Review of nonconformancies

SWX60743 01009

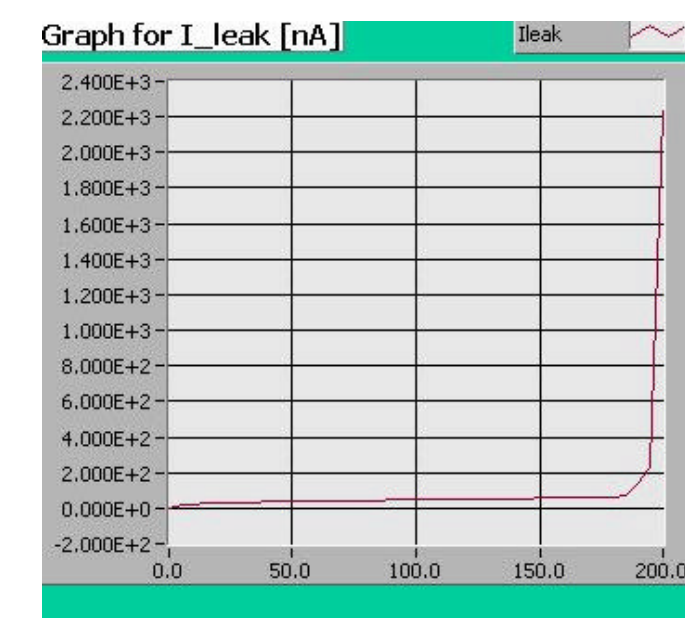
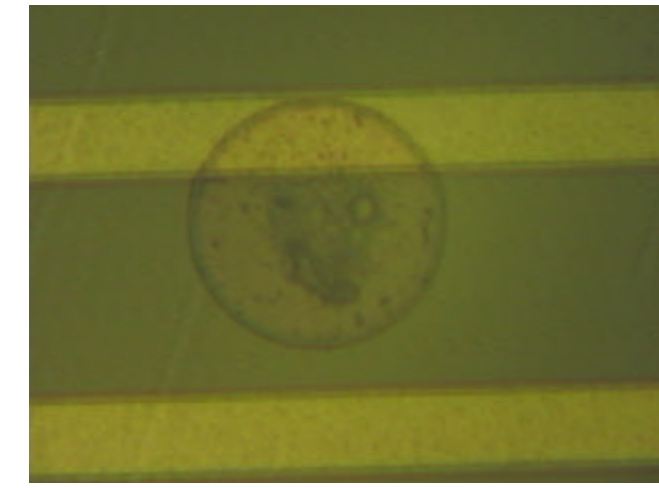
Optical Inspection: just two little spots

SWX60743 0095

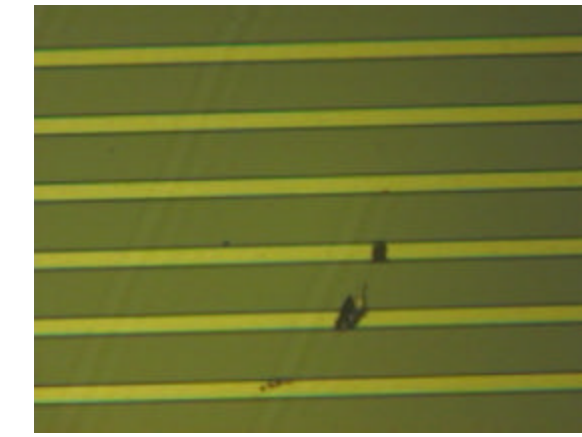
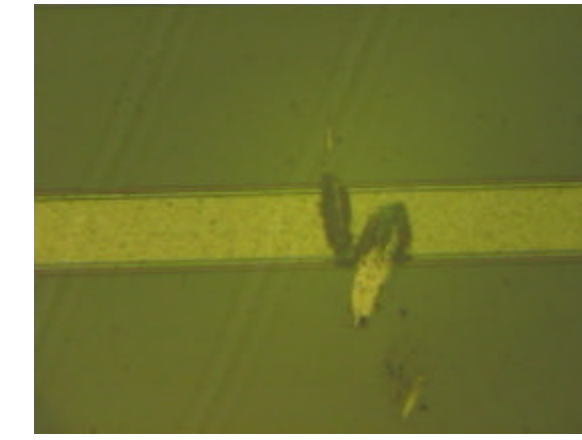
Optical inspection: scratch near the center of the detector.

SWX60745 01077

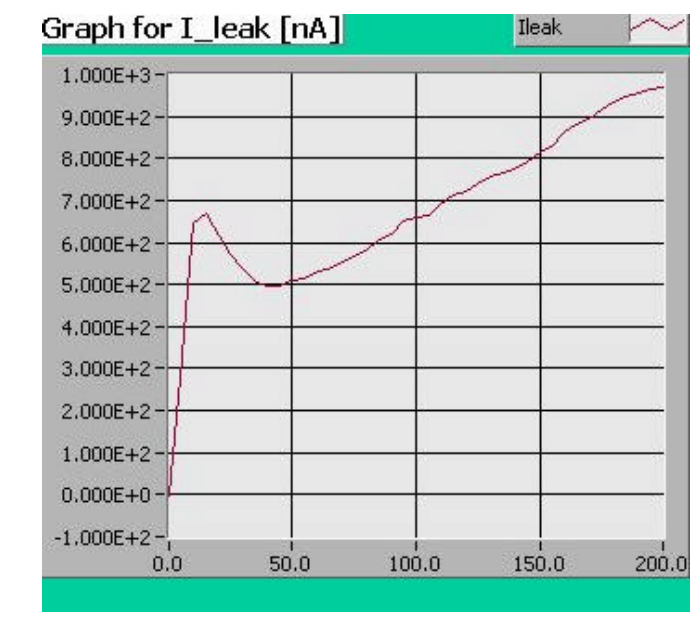
Optical inspection: nothing particular. Just a lot of dust and particulate around and a very little scratch.

SWX60745 01087

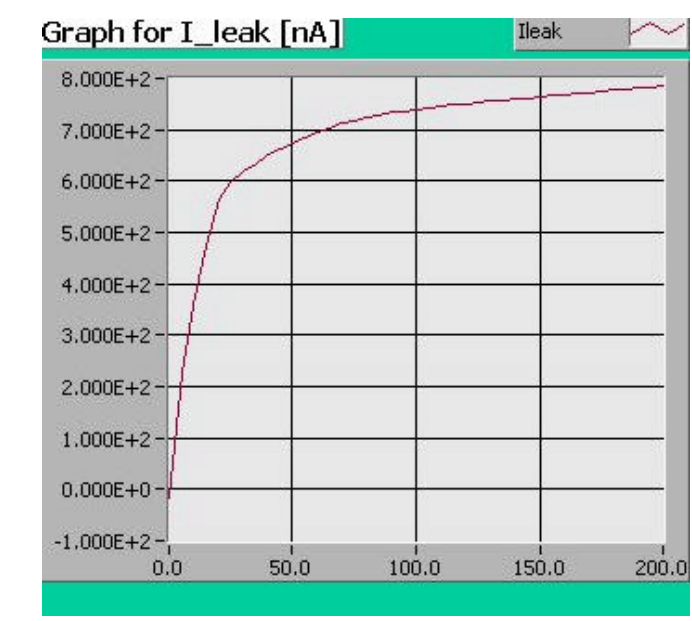
Optical inspection: nothing at all.

SWX60747 01135

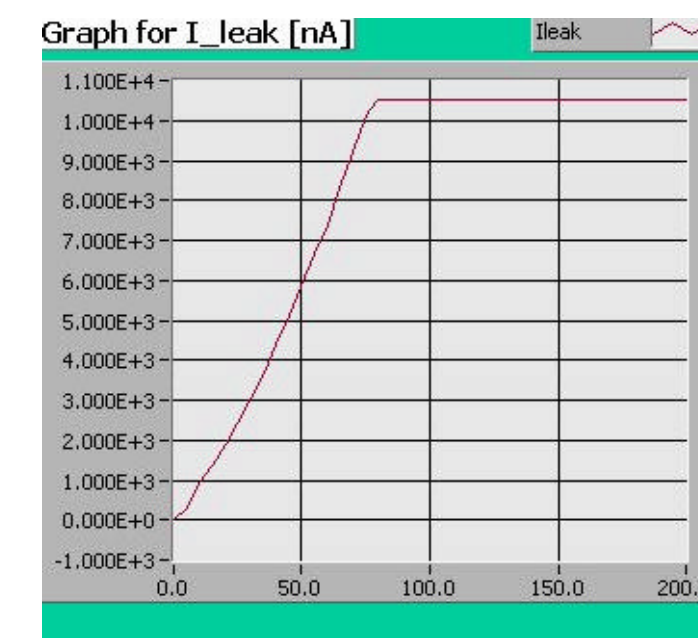
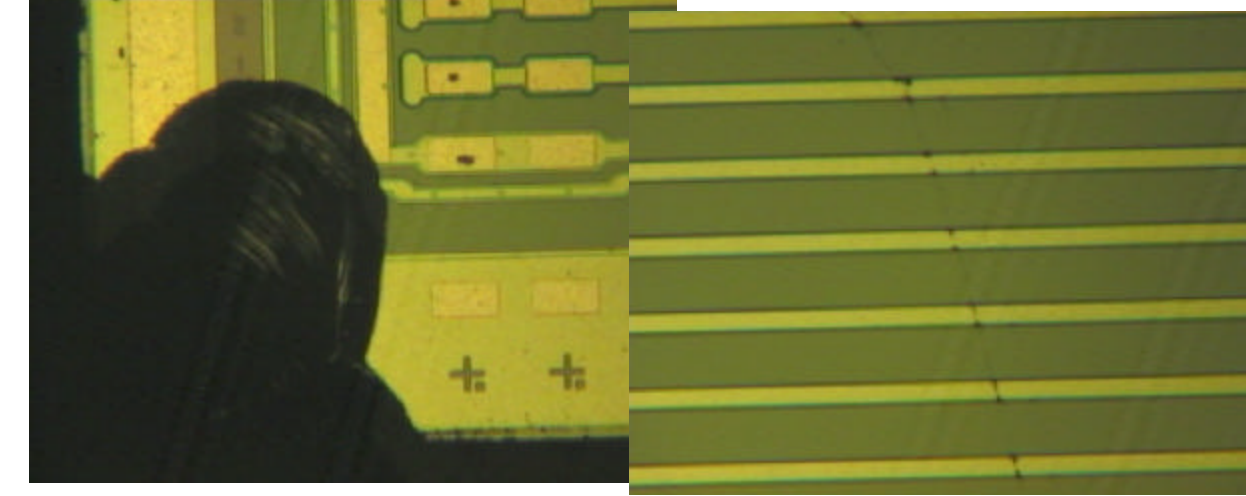
Optical inspection: bottom left corner missing:
there is a scratch.

SWX60709 00736

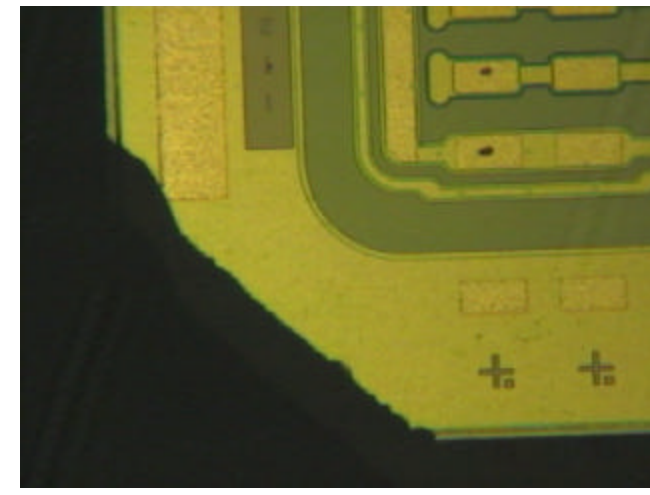
Missing bottom left corner.
